Application No. 10/544,120
Paper Dated: May 6, 2009
In Reply to USPTO Correspondence of February 6, 2009
Attorney Docket No. 0388-051649

REMARKS

FIG.5

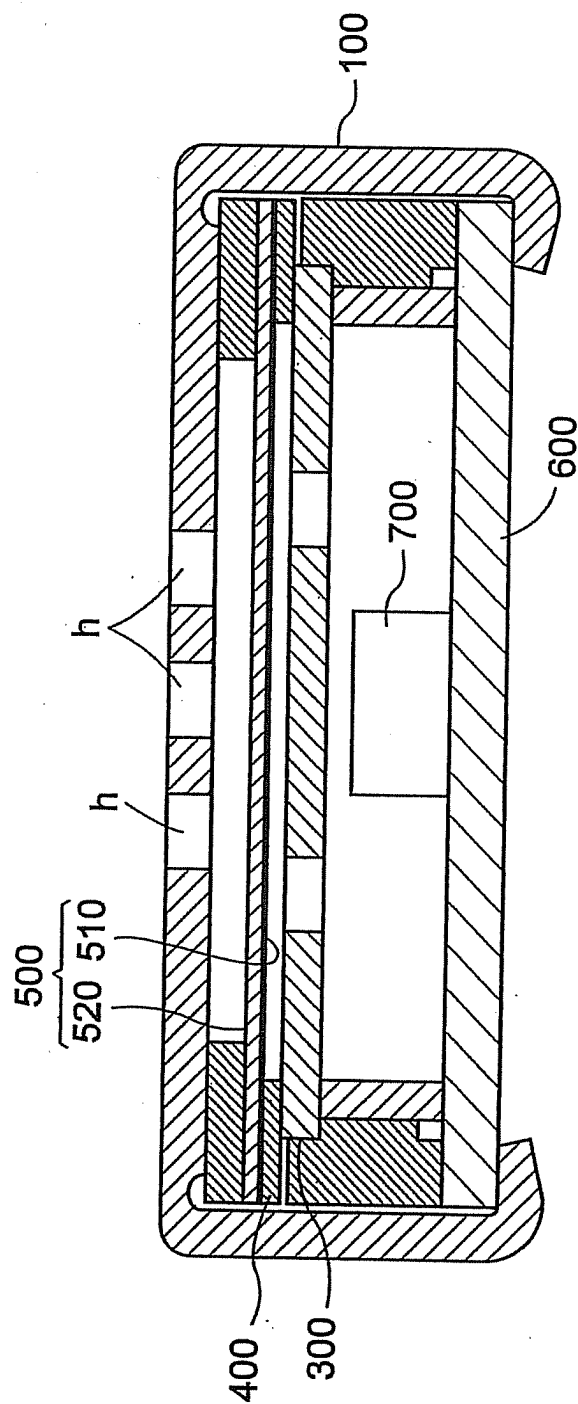
The Examiner has objected to Fig. 5 for not including a designation of "Prior Art." Fig. 5 has been amended to include a designation of "Prior Art."

The Replacement Sheet includes changes to Fig. 5. This sheet, which includes Fig. 5, replaces the original sheet including Fig. 5. The New Sheet includes newly added Fig. 6.
